**Eastern Corridor Segments II and III
Red Bank Corridor to I-275/SR 32 Interchange (PID 86462)
Public Open House
Meeting Summary Report**

**October 24 and 25, 2018 Public Open House
MEETING SUMMARY REPORT**

**October 24 and 25, 2018 Public Open House
CONCEPT EVALUATION and COMMENT SUMMARY**

Signalized Green Tee Intersection at SR 32 and Clough

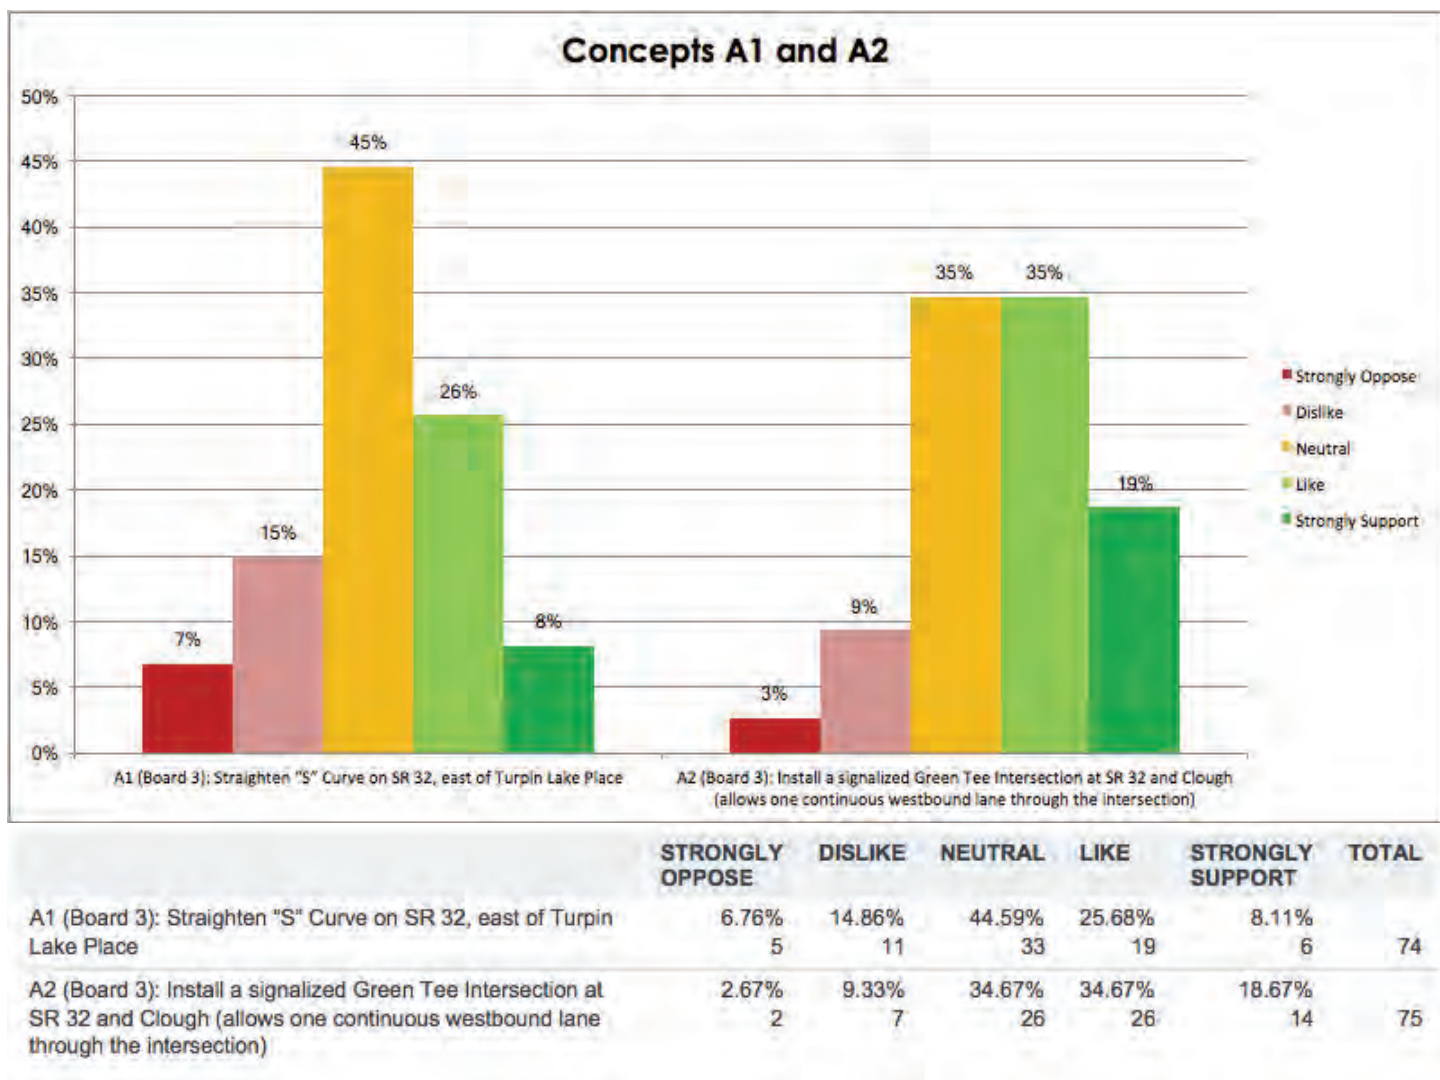
NO.	COMMENT	RESPONSE
1	A1 and A2 encourage speeding through an already fast road. Pedestrian improvements and speed-encouraging improvements are incompatible.	Thank you for your input. If concept A1 were to be advanced, improvements for bicyclists and pedestrians would be limited to providing a safer connection to the bike trail that already runs alongside SR 32 in this area. Currently, this shared-use path is separated from the road by approximately 40 feet. This distance would be maintained if adjustments were to be made to the alignment of the road. Concept A2 is not currently designed to include bicycle/pedestrian improvements because the shared-use path is outside of the proposed project limits. Your comments will be considered as we develop our recommendations.

NO.	COMMENT	RESPONSE
2	A1 seems unnecessary for cost.	Thank you for your comments. Your input is appreciated and will be taken into consideration as we evaluate the options and develop our recommendations.
3	<p><i>Received via email:</i></p> <p>I question if straightening the S curve on SR 32 is a high priority and is worth the cost. It is not that severe a curve. Improving the intersection of Clough and SR 32 is certainly a higher priority and will have more impact. Raising the roadway along that entire section so it doesn't flood and get closed during high water would be helpful. That would need to include doing something about the underpass which easily floods at the SR 32 and SR 125 intersection.</p>	<p>Thank you for your input. One of the primary reasons this concept was proposed was to raise the road out of the floodplain at this location. However, the cost of the project is a concern. When considering next steps, we will be evaluating project benefits vs. the cost as well as public comments before making our final recommendations.</p> <p>We have also been looking at options to address the flooding on the ramp from SR 125 to SR 32. After exploring possible solutions in consultation with the Advisory Committee, we have decided to advance a concept to install a drainage backflow preventer and make some grading adjustments around the bike path to reduce the frequency of flooding under the bridge. These efforts will be incorporated into the Little Miami Scenic Trail (LMST) Beechmont Bridge project (PID 107295) that is scheduled for construction in 2021.</p> <p>Your comments will be considered as we develop our recommendations.</p>

New Sidewalk from SR 125 to Reserve Circle

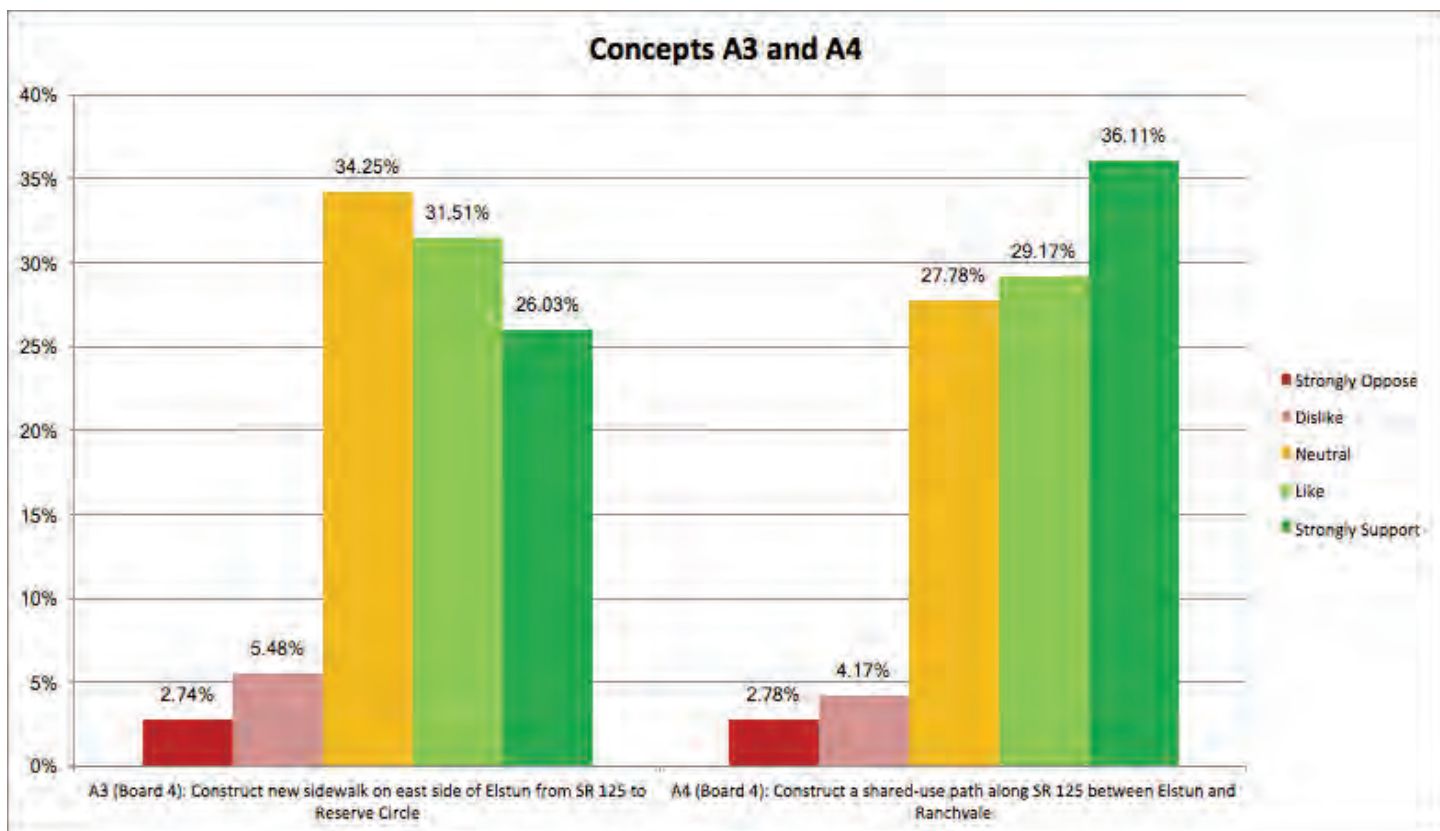
NO.	COMMENT	RESPONSE
1	A3 - Minor construction cost for major pedestrian safety improvement for residents on Elstun.	Thank you for your comments. Your input is appreciated and will be taken into consideration as we evaluate the options and develop our recommendations.

NO.	COMMENT	RESPONSE
1	A4 - Not a need.	Thank you for your comments. Your input is appreciated and will be taken into consideration as we evaluate the options and develop our recommendations.
2	A4 - This stretch of road is unsafe for pedestrians and bike riders because of high speed of traffic through the corridor that is encouraged by the "highway feel" of the large neighborhood roadway.	Thank you for your comments. Your input is appreciated and will be taken into consideration as we evaluate the options and develop our recommendations.
3	I am very concerned about the shared use path along Beechmont Avenue between Elstun Road and Ranchvale requiring additional right of way. Currently, a bike lane and buffer are paved. Why can the curb not be moved inward, and use the existing right-of-way? I also have a large concern about nothing being done to calm traffic at the intersection of Elstun and Beechmont.	<p>Thank you for your input.</p> <p>The purpose of this proposed path is to provide slower-moving bicyclists and pedestrians with safer space to travel in. While a bike lane is currently provided, it has been noted that only seasoned bicyclists are comfortable using it due to the grade and proximity to traffic. The shared-use path offset from the roadway could provide a more family-friendly connection.</p> <p>ODOT and the Advisory Committee members share your concerns about traffic at Elstun and Beechmont. Due to near-term redevelopment discussions at the Skytop site, it was not prudent to make changes at this intersection without understanding new traffic demands and patterns. Though concepts are not being advanced as part of the Eastern Corridor series of projects, it remains an issue that Anderson Township and other local jurisdictions will be looking to address as redevelopment plans are finalized.</p> <p>Your comments will be considered as we develop our recommendations.</p>

Shared-Use Path Along SR 125

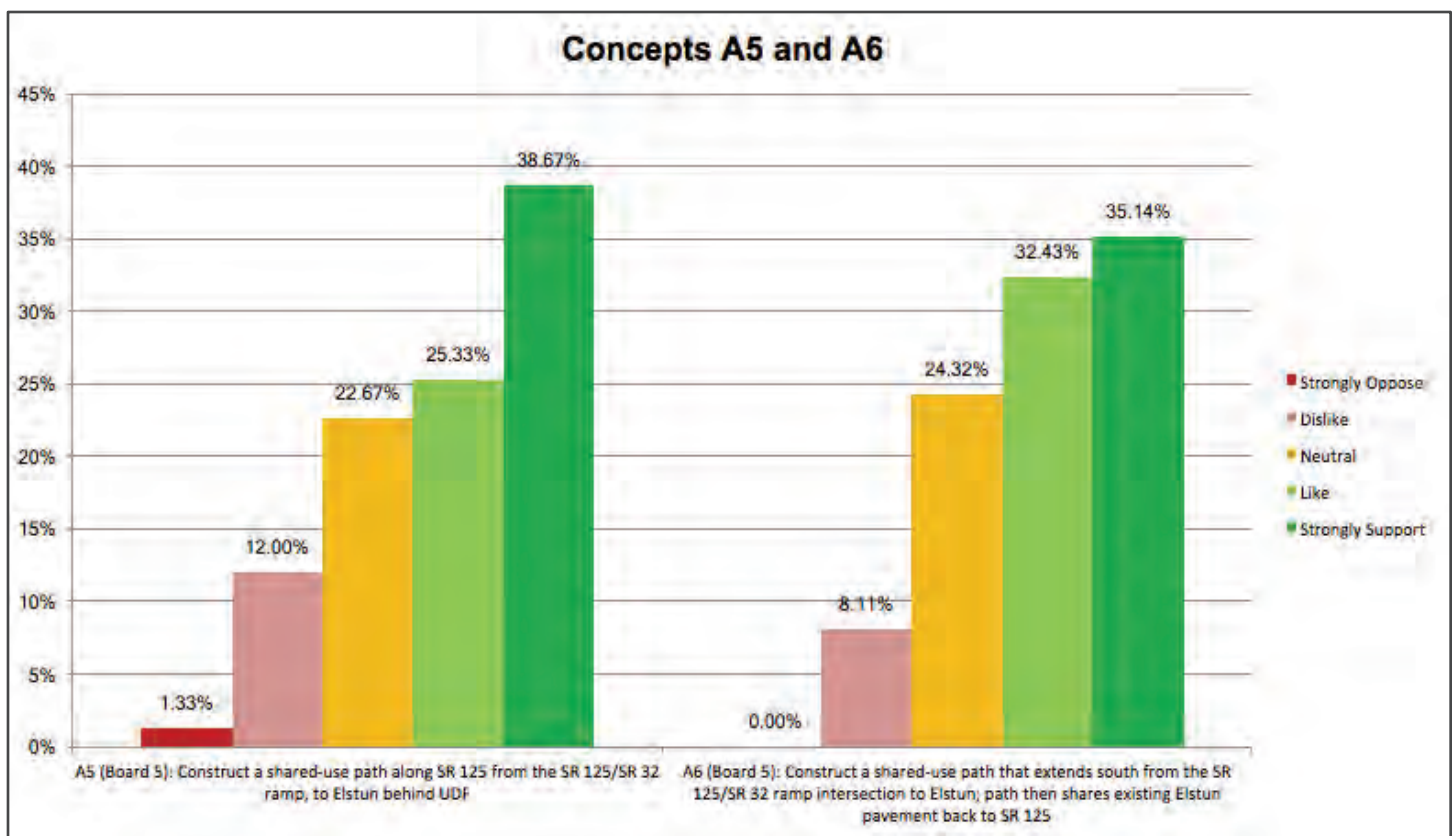
NO.	COMMENT	RESPONSE
1	A5 - Why is this connection needed?	Thank you for your question. The purpose of this connection is to provide bicyclists and pedestrians with a safe connection between Elstun and the Little Miami Trail without needing to travel with vehicular traffic on SR 125.
2	Prefer A5 over A6 to make direct connection to Beechmont bike lanes.	Thank you for your comments. Your input is appreciated and will be taken into consideration as we evaluate the options and develop our recommendations.
3	A5 and A6 - Providing a connection to the Ohio River bike trail network would allow an entire neighborhood to access this bikeway without vehicle travel. Major quality of life improvement and opens the	Thank you for your comments. Your input is appreciated and will be taken into consideration as we evaluate the options and develop our recommendations.

NO.	COMMENT	RESPONSE
	door for potential bicycle commuting. A5 would be more accessible and safer to use.	
4	Connecting the bottom of the Beechmont hill (i.e. UDF, Skytop Pavilion area) to Lunken/Little Miami Trail is most desired to keep cycling off of Beechmont levee and ramps to/from Route 32.	Thank you for your comments. Your input is appreciated and will be taken into consideration as we evaluate the options and develop our recommendations. Based on public comment and Advisory Committee discussions, Concept A6, discussed below, was revised to provide a separate shared-use path connection along Elstun.

NO.	COMMENT	RESPONSE
1	Prefer A5 over A6 to make direct connection to Beechmont bike lanes.	Thank you for your comments. Your input is appreciated and will be taken into consideration as we evaluate the options and develop our recommendations.
2	<p>A5 and A6 - Providing a connection to the Ohio River bike trail network would allow an entire neighborhood to access this bikeway without vehicle travel. Major quality of life improvement and opens the door for potential bicycle commuting. A5 would be more accessible and safer to use.</p> <p>If A6 is moved forward, can A3 be converted to mixed use trail and extended further down Elstun to avoid a shared roadway?</p>	<p>Thank you for your comments. Your input is appreciated and will be taken into consideration as we evaluate the options and develop our recommendations.</p> <p>Based on public comment and Advisory Committee discussions, Concept A6 will be revised to provide a shared-use path connection along the entire length without using a shared roadway segment. The sidewalk connection along Elstun proposed in Concept A3 would be replaced by the shared-use path.</p>

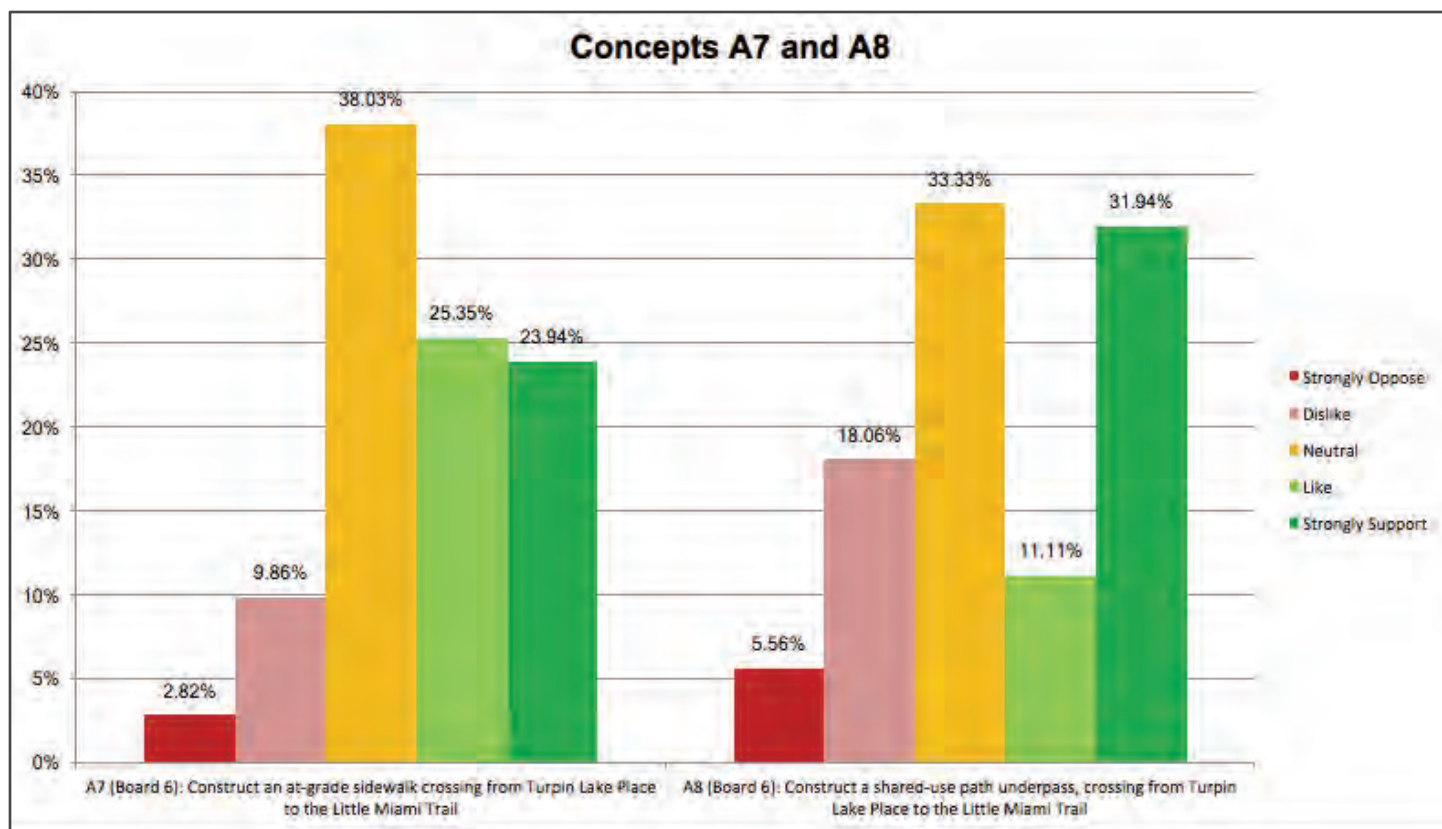
NO.	COMMENT	RESPONSE
1	A7 - How many pedestrians impacted here?	Thank you for your question. This concept would most likely be advanced in coordination with concept A9 which would establish a new bike/pedestrian connection between the Five Mile Trail and the Little Miami Trail using the streets in the Turpin Hills neighborhood. The A7 connection would be used to cross SR 32 to the Little Miami Trail, therefore, a higher level of use beyond the residents in houses located on Turpin Lake Place would be expected. A projection of the number of anticipated users has not yet been developed.
2	A7 - This pedestrian crossing will be creating a major safety hazard. There is no way drivers will yield to a pedestrian signal while traveling 50+mph through this	Thank you for your comment. ODOT and the SR 125/SR 32 Advisory Committee have discussed similar concerns. Should this concept be advanced, the group discussed completing a speed study to determine if a lower speed limit along SR 32 would be warranted. This would need to

NO.	COMMENT	RESPONSE
	area especially if the roadway is straightened.	be further explored before making any decisions to construct the project.
3	A7 - 50,000 for a sidewalk? For 15 houses?	Thank you for your comment. This concept would most likely be advanced in coordination with concept A9 which would establish a new bike/pedestrian connection between the Five Mile Trail and the Little Miami Trail, using the streets in the Turpin Hills neighborhood. The A7 connection would be used to cross SR 32 to the Little Miami Trail, therefore, a higher level of use beyond residents in the houses located on Turpin Lake Place would be expected. Your input will be taken into consideration as we develop our recommendations.

NO.	COMMENT	RESPONSE
1	A8 - Major investment to benefit minimal number of residents even if A9 is carried forward. This alternative is considered a primary need versus the Elstun bikeway connection is considered secondary which would serve the entire neighborhood of Mt Washington. This need designation does not make sense.	Thank you for your comment. As you noted, this concept would most likely be advanced in coordination with concept A9 which would establish a new bike/pedestrian connection between the Five Mile Trail and the Little Miami Trail, using the streets in the Turpin Hills neighborhood. The A7 connection would be used to cross SR 32 to the Little Miami Trail, therefore, a higher level of use beyond residents in the houses located on Turpin Lake Place would be expected. Your input will be taken into consideration as we develop our recommendations.
2	<i>Received via email:</i> A8 - An overpass instead of an underpass would make more sense since that area floods.	Thank you for your comment. Typically, an overpass carries a much higher cost and tends to be under-utilized as users choose to not use stairs or ADA compliant ramps to go up and over. Since the roadway concept in this area also is addressing flooding by raising the roadway, the added elevation provides an opportunity for the underpass.
